Re: County of Sacramento Comments on Notice of Preparation for Environmental  
Impact Report – Delta Conveyance Project

## Internal Technical Review Panel Memorandum

<b>To:</b>	Kathryn Mallon, DCA Executive Director Tony Meyers, DCO Executive Director	<b>Project:</b> Delta Conveyance
<b>From:</b>	Werner Burger, Herrenknecht John Kennedy, Dragados Jeff Petersen, Kiewit Dave Rogstad, Frontier-Kemper Kenji Yamauchi, Obayashi Dan Adams, McMillen Jacobs Renée Fippin, McMillen Jacobs	
<b>Date:</b>	January 31, 2020	<b>Job No.:</b> 5226.2
<b>Subject:</b>	ITR December Workshop on Tunnel and Shafts - Report

**Figure 1. TBM Drive Lengths with Herrenknecht TBMs**

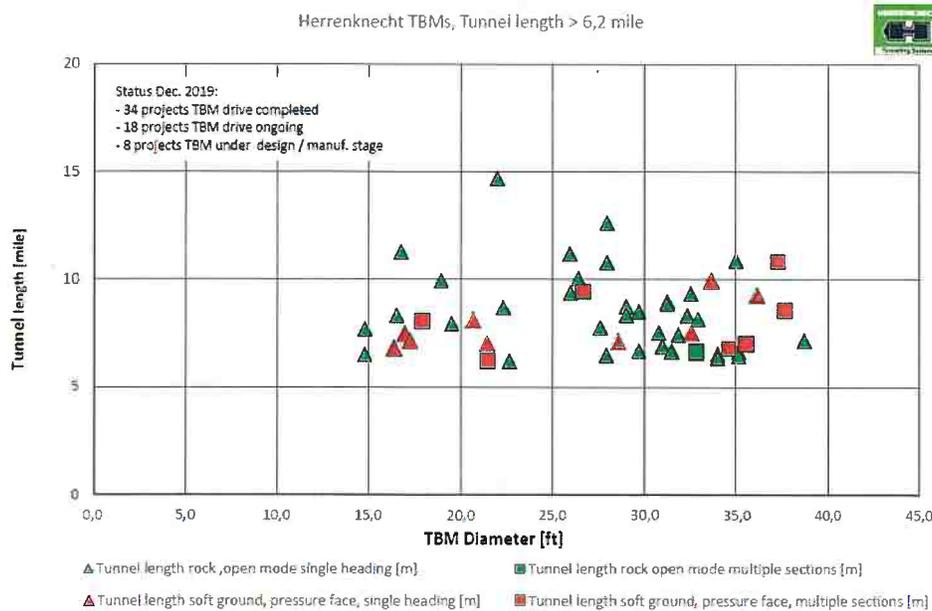
The ITR's opinion is that TBM drive lengths up to 15 miles are achievable for this project. The key reasons being that 1) the alluvial deposits are relatively uniform and favorable to tunneling, 2) the inner diameter of the tunnel provides sufficient space to support of operations, and 3) issues that typically jeopardize TBM longevity, including high groundwater pressures, mixed ground conditions, and high boulder frequencies, are not present for this project.

The achievability of long tunnel drives is primarily driven by logistics. The size of the Delta Conveyance tunnel and favorable geology suit an extended drive without substantially raising the risk profile of the project. A summary of long tunnels is presented on Figure 1.

**Figure 2. Safe Haven Concept**

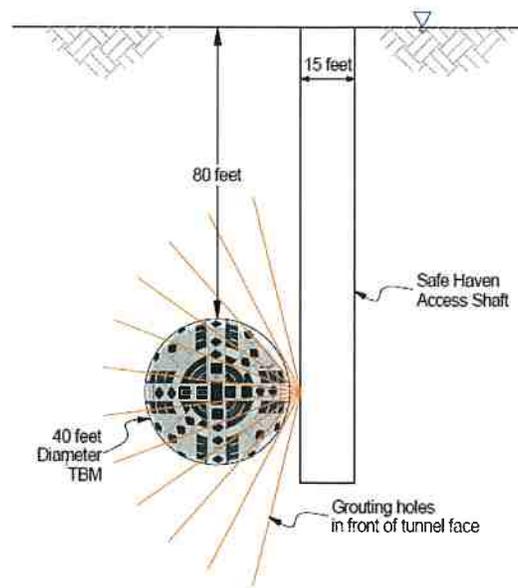
A safe haven is a location where unpressurized access to the TBM face can be achieved for inspection and maintenance purposes. The ITR recommend a minimum of one safe haven per tunnel drive, preferably fairly early in the drive to confirm assumptions and monitoring efforts on wear. The ITR debated the need for a second safe haven. It is prudent to have safe havens, but rarely is a safe haven in the location one needs it. If allowable within the constraints of the environmental documentation, it is recommended that an additional allowance for “unlocated” safe haven(s) (e.g., unplanned intervention) be included. This means, the contractor is allowed to develop a safe haven where necessary to support operations. It’s important to point out that certain sites within reason can be excluded – such as in areas of biological resources.

The TBM safe haven can be a low-impact solution. As shown in Figure 2, the ITR proposed a small 15-foot diameter shaft which could be a drilled shaft, sunken cast-in-place concrete or vertical shaft sinking (VSM) excavation with segmental lining. From within the shaft, ground treatment such as grouting or freezing can be performed in the horizontal direction providing coverage for the cutterhead. This process will minimize surface impacts as well reduce the surface impact schedule for the safe havens.

**Figure 3. Studied Central (Yellow) and Eastern (Blue) Alignment Corridors**

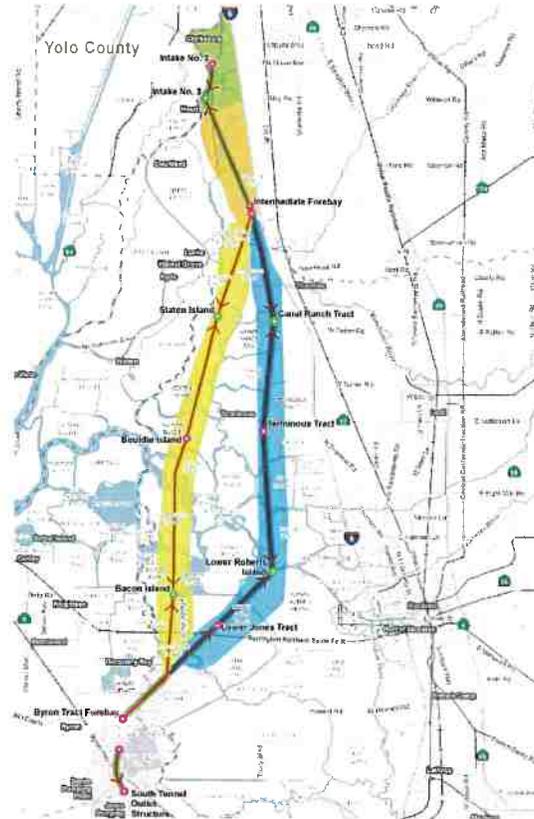
The project team discussed and compared the current tunnel alignments under study in the Central (yellow) and Eastern (blue) corridors as shown in Figure 3.

The consensus among the ITR was that the Central Corridor is logistically impractical and the ITR does not recommend this corridor be further studied. The shaft locations are located a significant distance from Interstate 5, accessible by only farm roads with hindrances such as narrow weight-restricted bridges and single lanes. This makes supporting large operations, which requires a constant transfer of materials and people in and out, impractical and expensive as well as difficult to price. In addition, addressing safety, including hospital access and tunnel safety duplication, creates a costly layer of redundancy without definitive costs. While it was recognized that extensive roadway, levee, and likely barge improvements could be constructed as part of the project for the Central Corridor, the ITR offered:

- The cost of improvements to provide reliable and safe access and egress at each site would exceed the cost of additional length of tunnel required for the East alignment.
- Levee re-build, barge, and site preparation & stabilization is temporary work, and much of it (e.g. barge facilities) will require removal;
- Site improvements and prep is driven by means and methods;

- Labor and construction safety costs, regardless of improvements, are too uncertain to price due to the location and distance from any shaft on the Central Alignment to developed land/communities.

For the reasons described above, the ITR recommended adjustments to the alignment as described in Section 3.1 which will facilitate large scale tunneling.

Figure 4. Recommended Far East Alignment Corridor

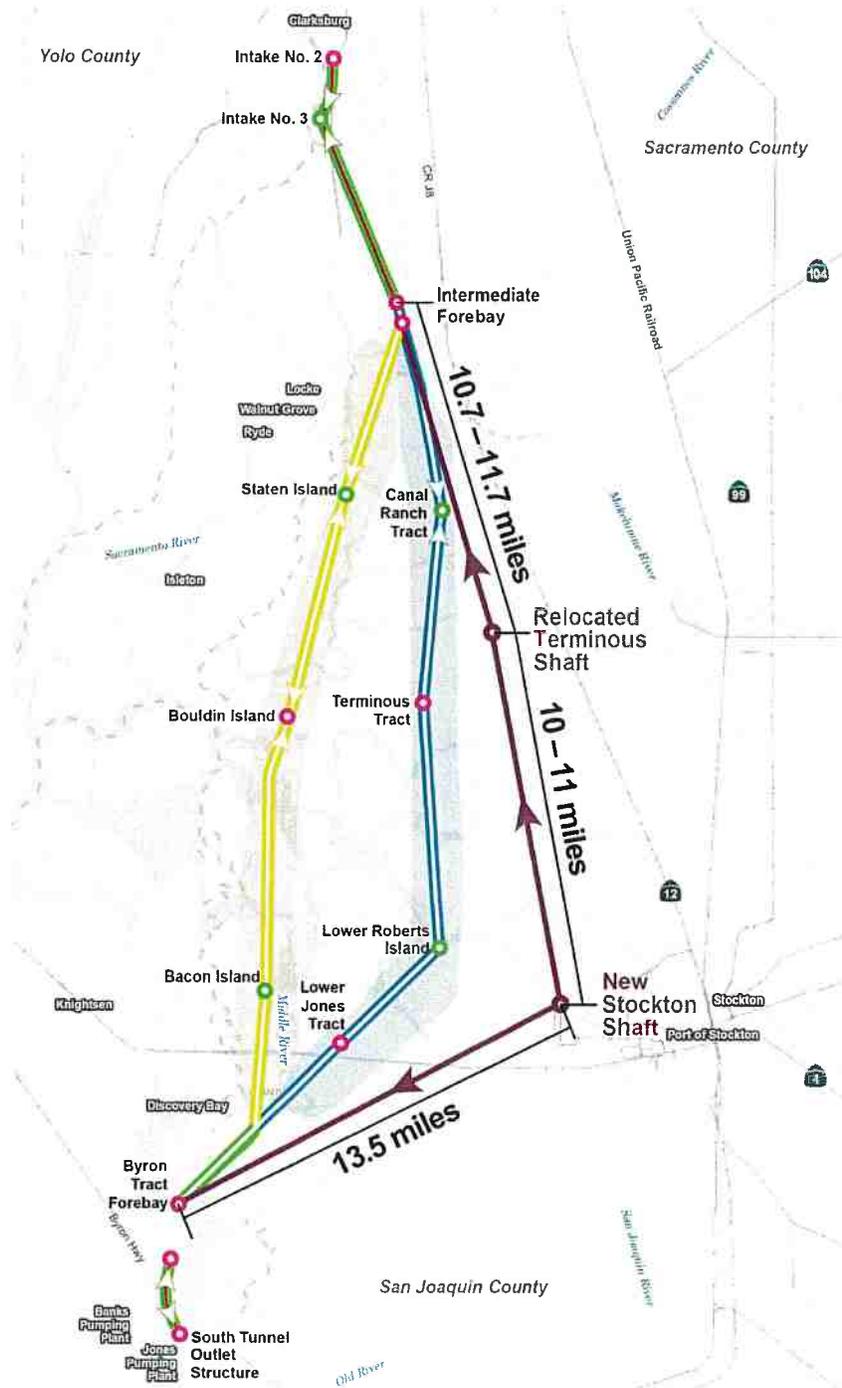
The ITR recommended that between the Terminous Shaft and the Lower Roberts Shaft, the alignment be shifted further to the east and closer to Interstate 5. Specifically, the following recommendations are made:

- Relocate Terminous shaft to the north and east
- Move shaft at Lower Roberts Island, south-east to industrial land in/closer to Stockton
- Eliminate Lower Jones Tract and Canal Ranch shafts

These proposed changes expand and/or shift the East (blue) corridor east as shown below on Figure 4. The longest tunnel drive length would become approximately 13.5 miles.

For the vertical alignment, the ITR recommends raising the tunnel alignment by one tunnel diameter. This will reduce the operating pressures considerably which is beneficial to the overall operation of the machine and safety of the workers.

Figure 6. New Stockton Shaft

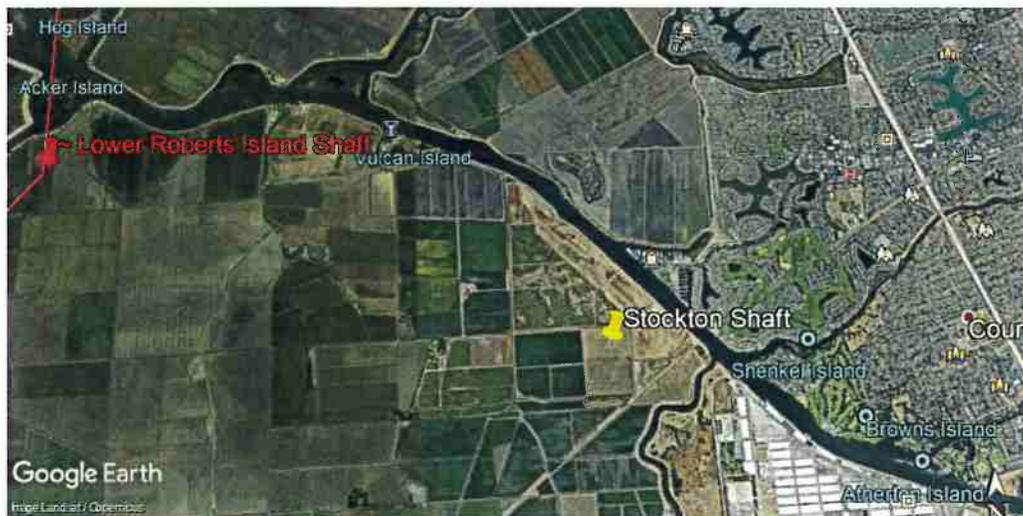
Figure 6 shows the general placement of a New Stockton Shaft. In general, the recommendation is to shift east along the San Joaquin River closer to industrialized Stockton. The pin location shown in Figure 6 is just adjacent to the Port of Stockton and eliminate additional road widening and improvements to get to the Lower Roberts location as well as time. This site allows for segment production if desired and barge facilities to be developed. It is also adjacent to rail. This could be an important advantage, particularly when considering the contract packaging discussed below as a new Stockton Shaft as proposed would have 50% of the tunnel material (supply in, tunnel material out) flowing through that location.

Figure 8. Recommended Tunnel DB Contract Packaging

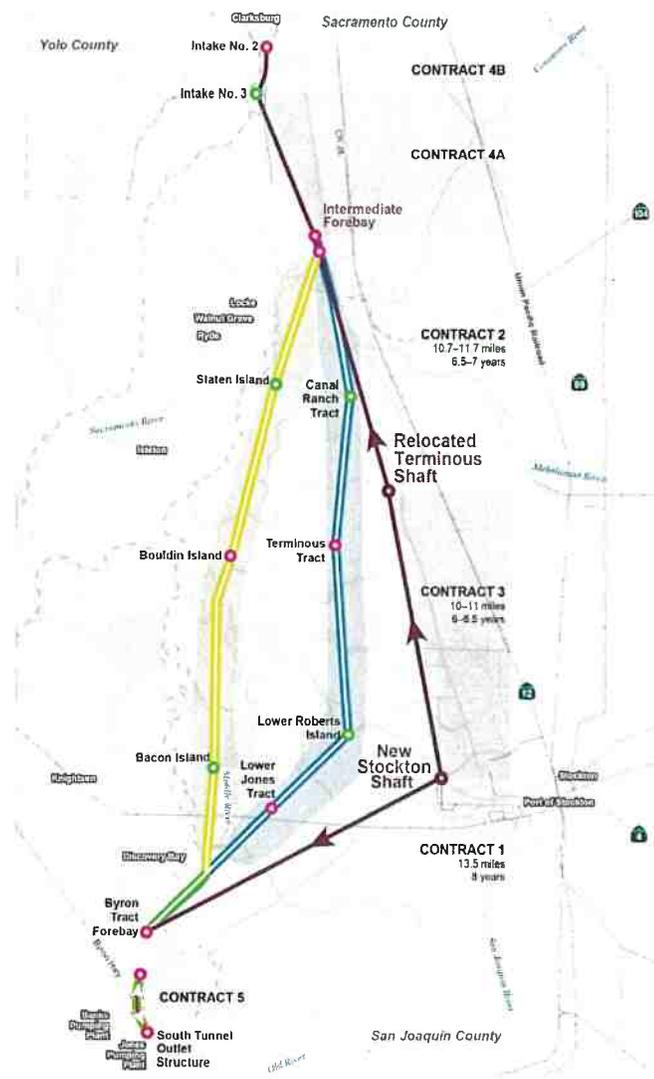
The ITR recommends five tunnel design build contracts in order of release as follows and shown in Figure 8:

- Contract 1: Stockton Shaft to Byron Forebay
- Contract 2: Terminus Shaft to Intermediate Forebay Shaft
- Contract 3: Stockton Shaft to Terminus Shaft
- Contract 4A: Intermediate Forebay to Intake 3
- Contract 4B: Intake 3 to Intake 2
- Contract 5: South Outlet Tunnels (twin tunnels)

If the release of contracts begins in Quarter 1 of 2023, completion of the project tunnels by 2035 is achievable. The ITR recommends that each contract be separated by approximately 9 months.

It is recommended that the logistics for each site including shaft height above ground surface, finalization of power drop, etc. be included in the DB contracts as it allows the contractor to set up the sites to suit their means and methods. Any early works contract can include items such as widening of the ½ mile of Highway 12, Twin Cities Road and improvements to the Clifton Court area.
